Modification Airmate (stereo AUX) from 220V to 110V

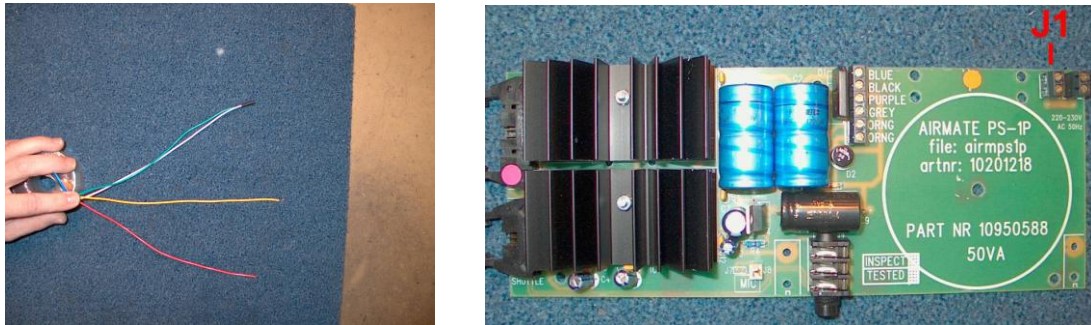
The following picture displays the 220V wiring. Green and White are connected to each other and Red and Yellow are connected to connector J1.

To modify the power-supply there are two necessary steps to follow.

- 1) The power-cabling to the transformer needs to be rerouted.
- 2) The fuse needs to be replaced.

Twist the Green and the Red wire together. Twist the White and the Yellow together.

ATTENTION: DO NOT SOLD THE WIRES TOGETHER

Then connect both wires to the connector J1.

The red indicator (arrow) specifies the point (2 holes) where the wires need to be mounted to the Print Circuit Board with a tie-wrap.

The fuse-box is integrated in the AC socket. The fuse must be replaced from a 0.5A to a 1A.

Make sure the 220V marking on the fuse-holder is on TOP!!! Else the device will not function.
